AS-BUILT CREW PRINT		<small>ALL REQUIRED GROUND RODS HAVE BEEN DRIVEN & VERIFIED TO BE WITHIN FPL STANDARDS. VALUES ARE SHOWN AT ALL LOCATIONS.</small>		<small>JOB CERTIFIED COMPLETED AS SHOWN ON THIS AS-BUILT PRINT. MATERIAL CHANGES SHOWN IN RED.</small>		AS-BUILT COPY	
FOREMAN'S SIGNATURE _____ DATE _____		FOREMAN'S SIGNATURE _____ DATE _____		SUPERVISOR'S SIGNATURE _____ DATE _____		INITIALS _____ CERT. DATE _____	
Easement?	Yes <input type="checkbox"/> No <input checked="" type="checkbox"/>	Survey/Stake?	Yes <input type="checkbox"/> No <input checked="" type="checkbox"/>	Work with SMO?	Yes <input type="checkbox"/> No <input checked="" type="checkbox"/>	FPL FDOT – City of Pahokee Install 50 New Lights v/o SR 15/US 441 (from S of Shirley Dr to Main St), Pahokee, FL 33476	
Tree Work?	Yes <input type="checkbox"/> No <input checked="" type="checkbox"/>	Designer/Stake?	Yes <input type="checkbox"/> No <input checked="" type="checkbox"/>	CT/Special Mtr?	Yes <input type="checkbox"/> No <input checked="" type="checkbox"/>

FDOT - City of Pahokee
 Install 50 New Lights
 v/o SR 15/US 441 (from S of Shirley Dr to Main St), Pahokee, FL 33476
 Designed by: Jessica Builes Date: 02/20/23
 Drawn

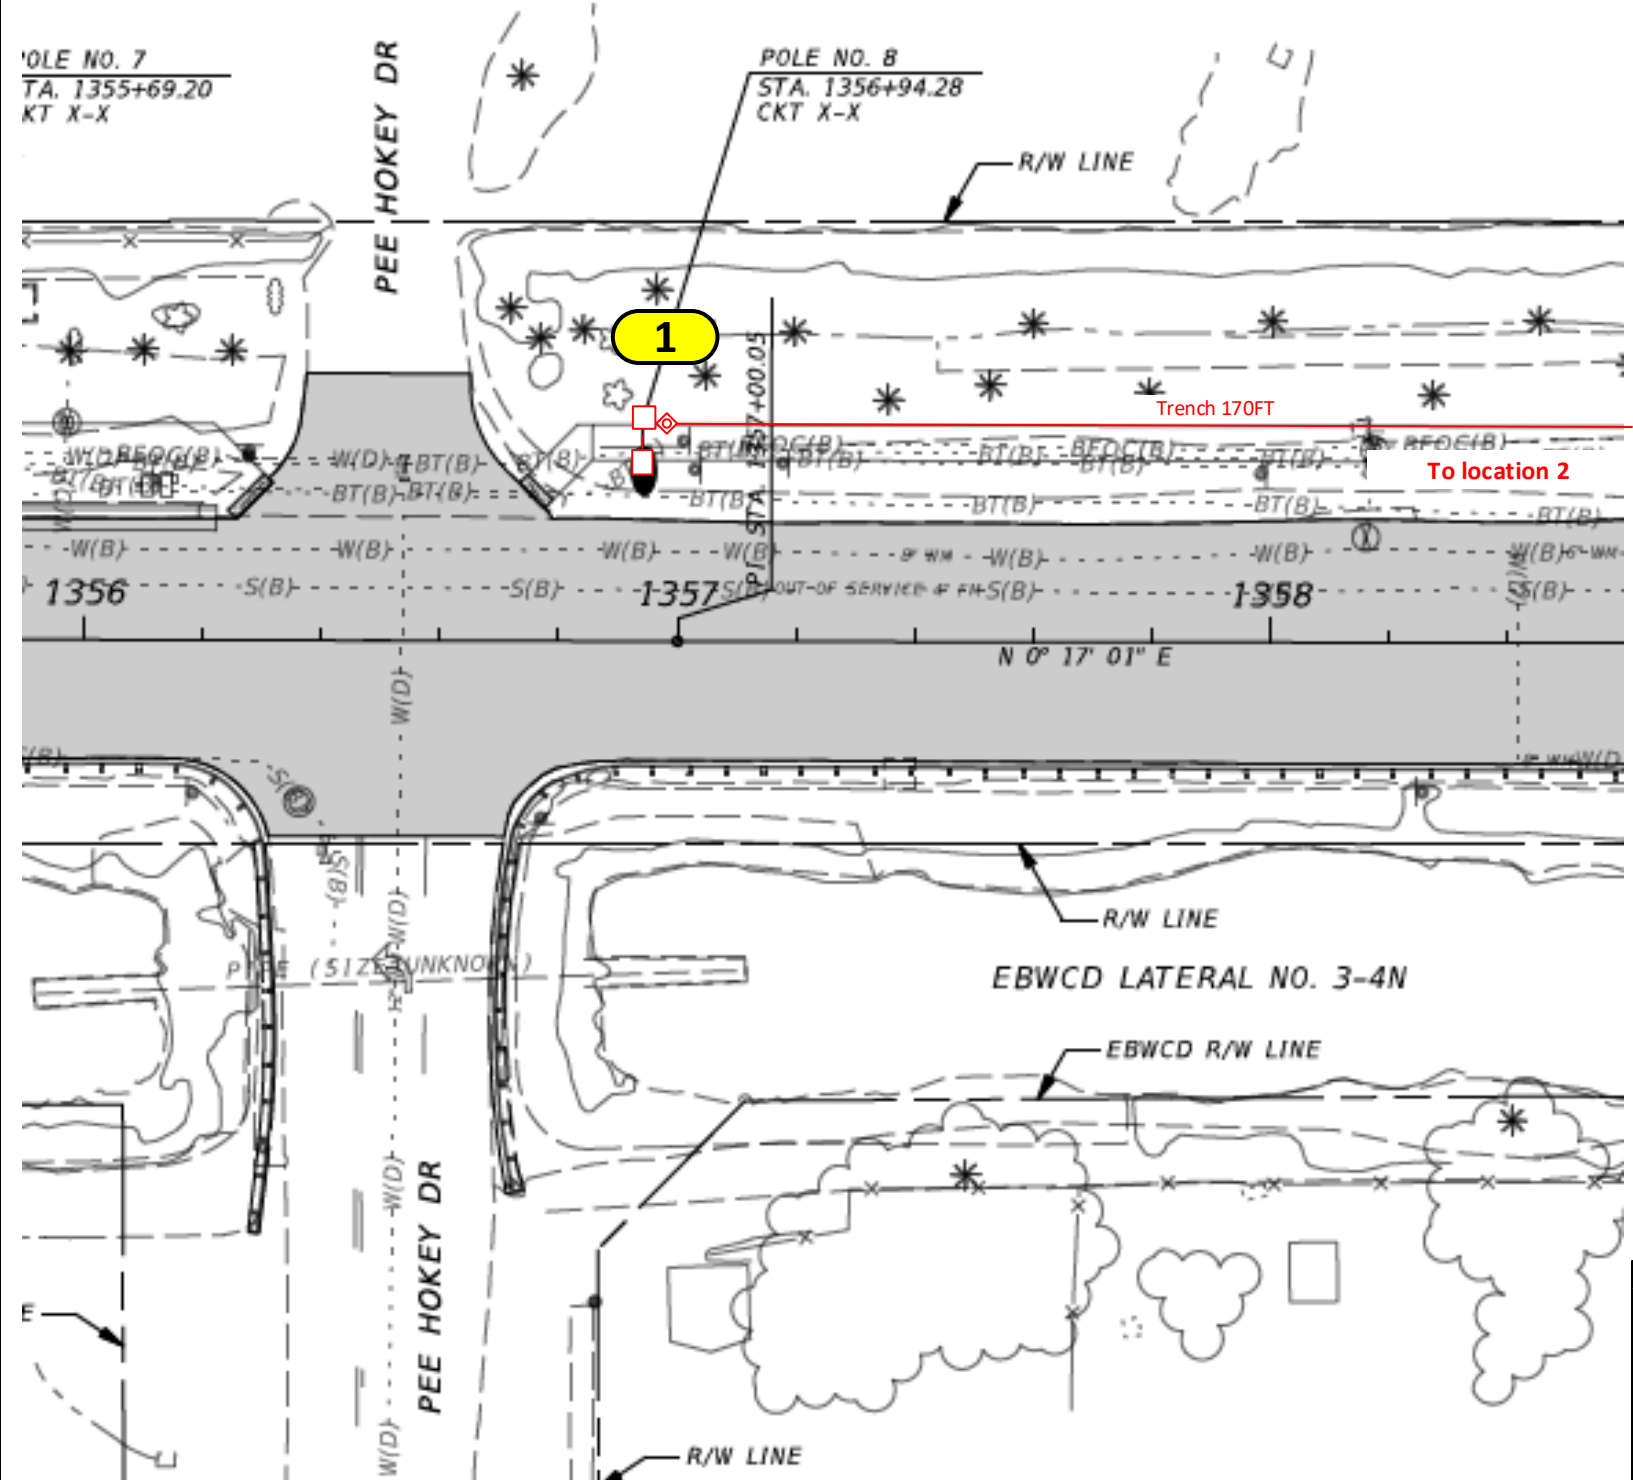
Loc. 1 to 6 need to be fed from UG. For Safety reasons, lines cannot go UG to OH

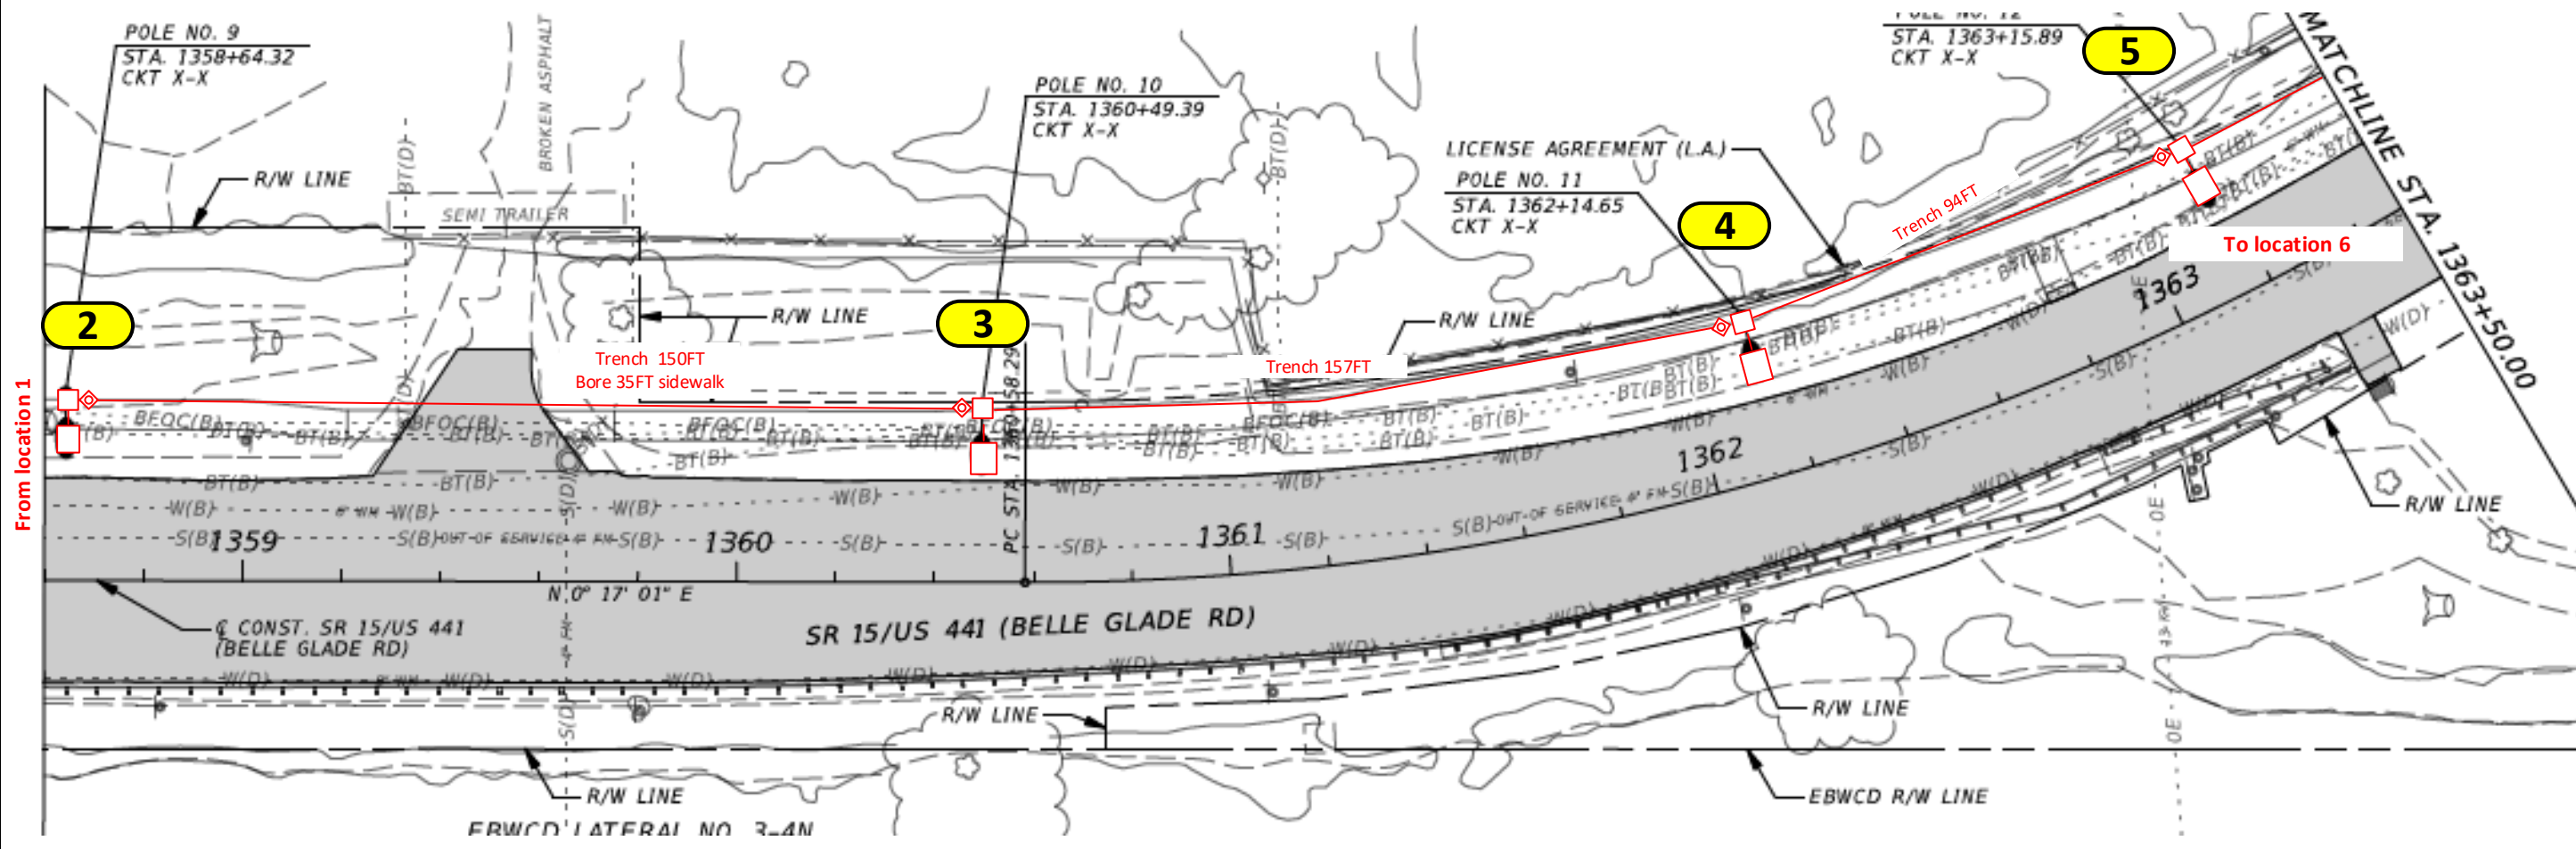
Loc. 1 to 6 need to be fed from UG. For Safety reasons, lines cannot go UG to OH

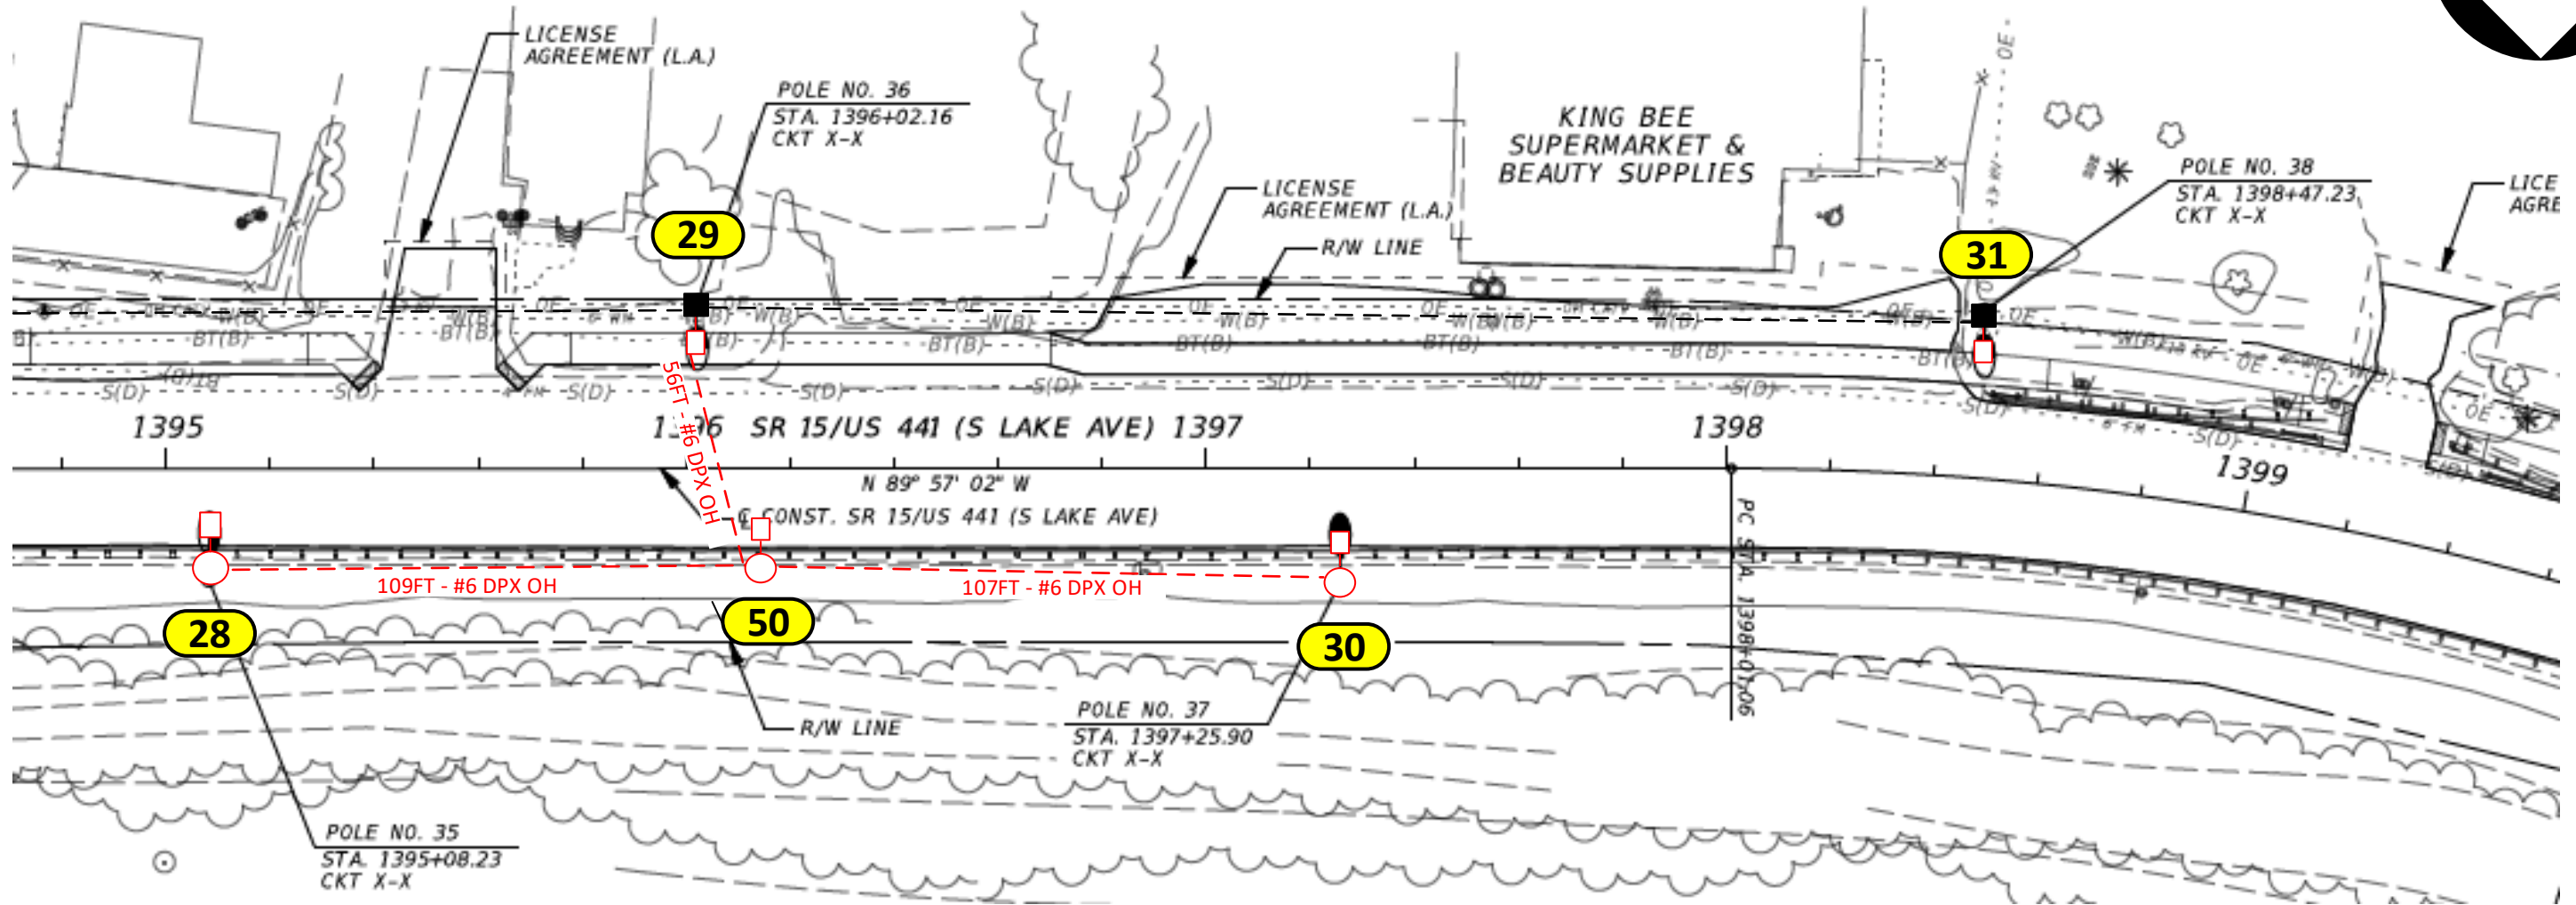
Mounting Height on Distribution Pole cannot be determined by the Customer

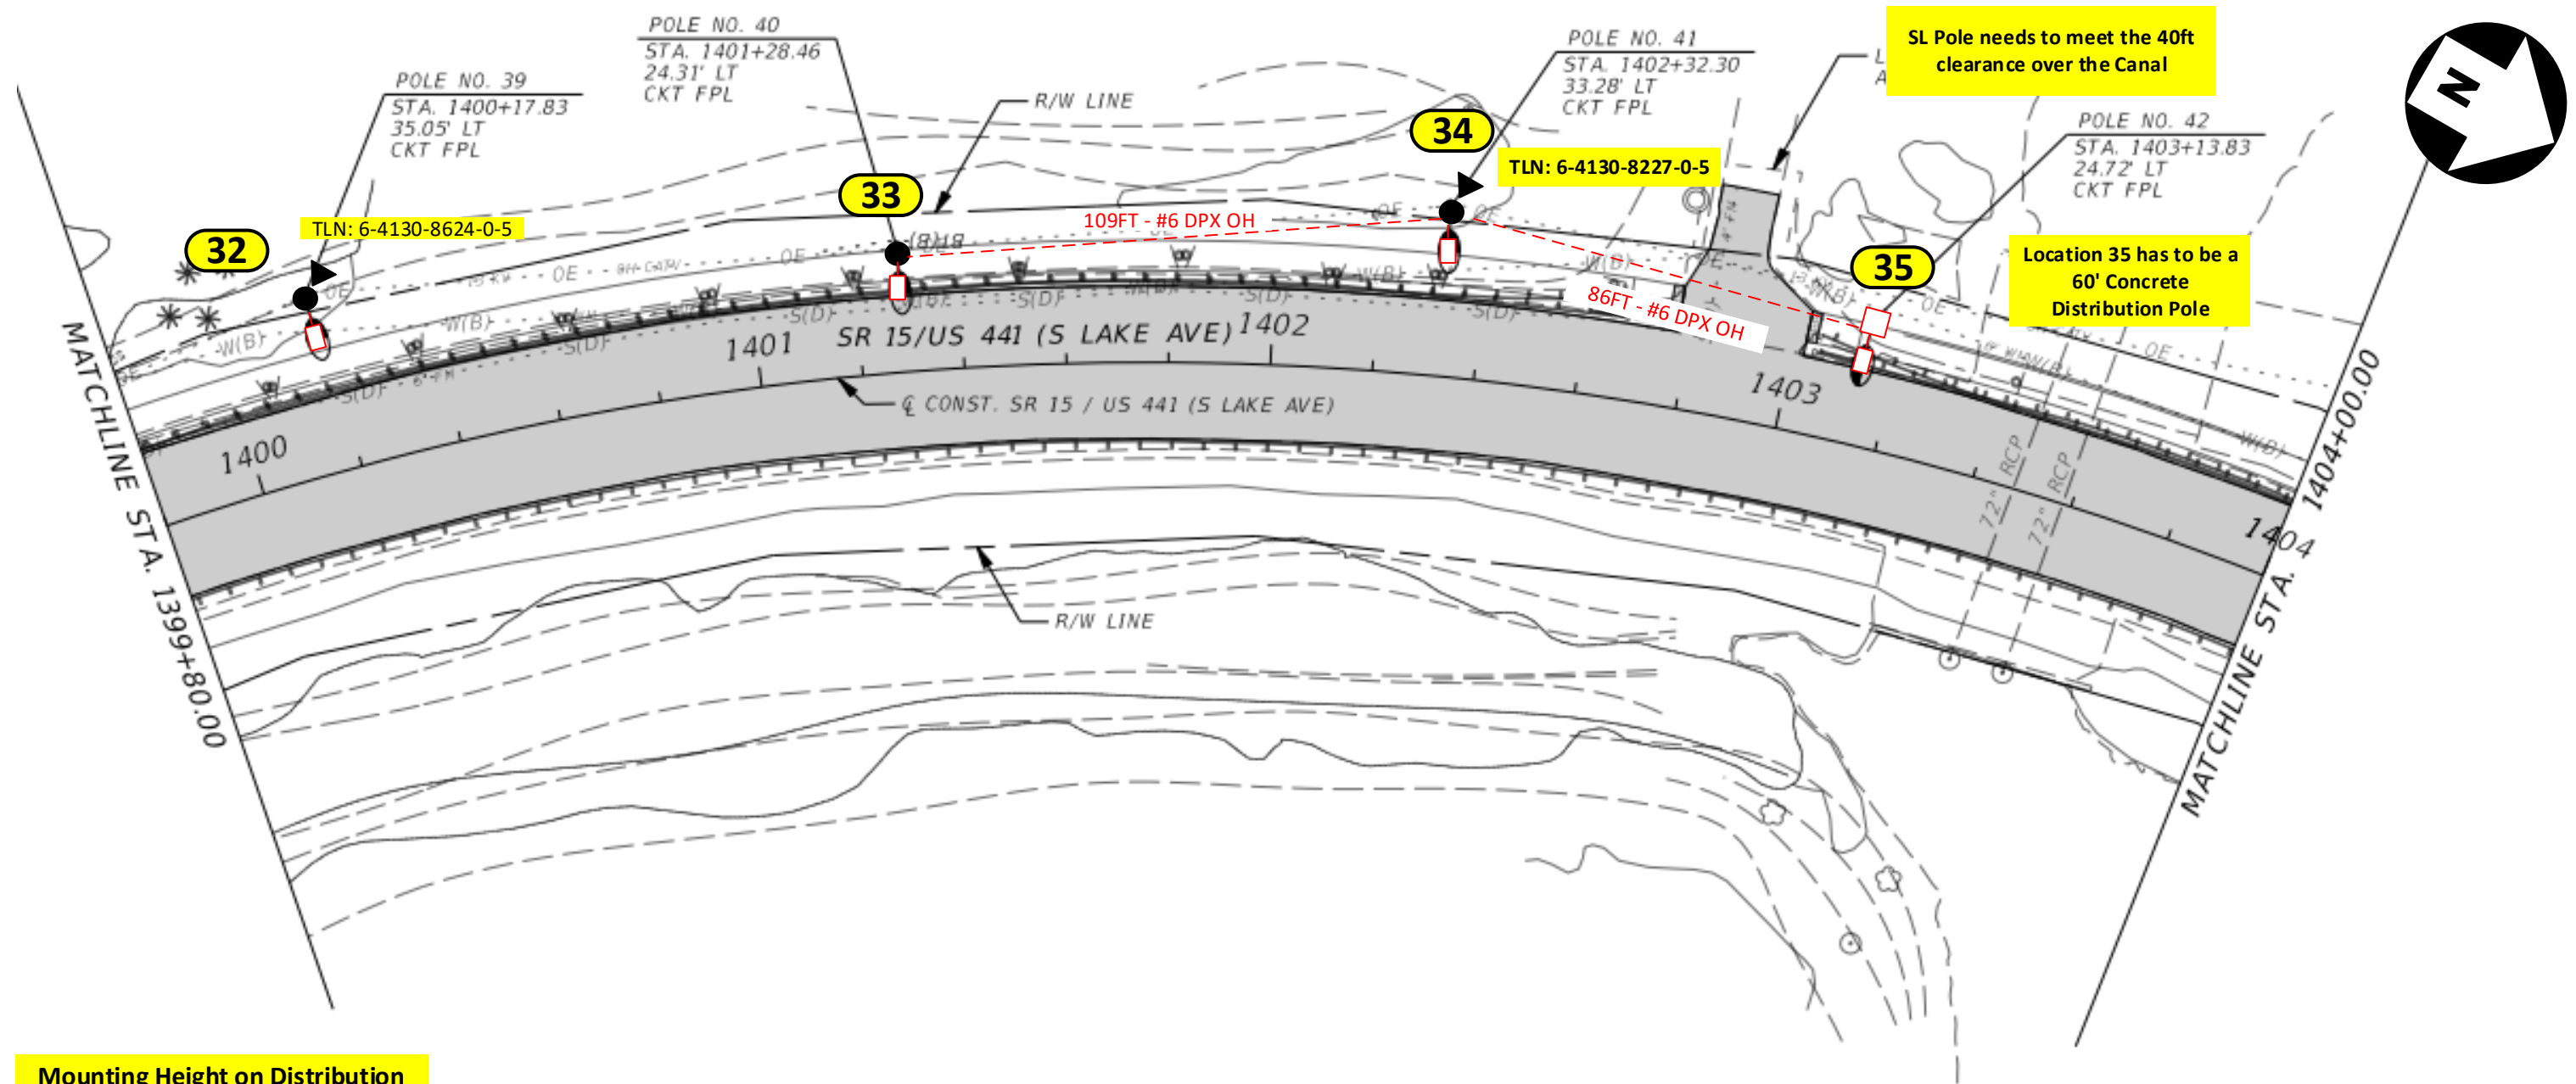
SL Pole needs to meet the 40ft clearance over the Canal

Location 35 has to be a 60' Concrete Distribution Pole

Mounting Height on Distribution Pole cannot be determined by the Customer
